Access Compliance Report

Public Rights-of-Way

Intersection ID: 11640	Main Street: E_W_T_HARRIS_BV	Cross Street: WILLIAMS_RD	Location: SW
ADA ID: 14EE1647BE51	Ramp Type: PerpDiag	Initial Pass/Fail: Fail	Overall Compliance: No
Codes/Mitigation Info/Possible Solution		Field Measurements/Component Compliance	
Severity Score: 12.5

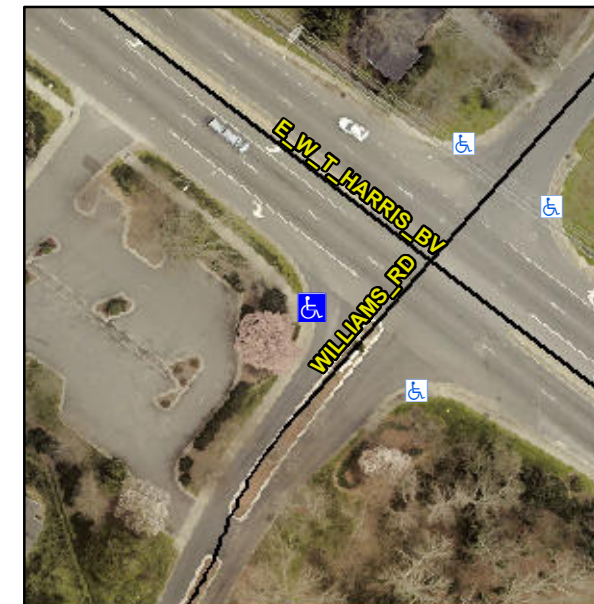
Remove & Replace Curb Ramp With Two New Directional Ramps or Equivalent.

Not Found, R304.2.2
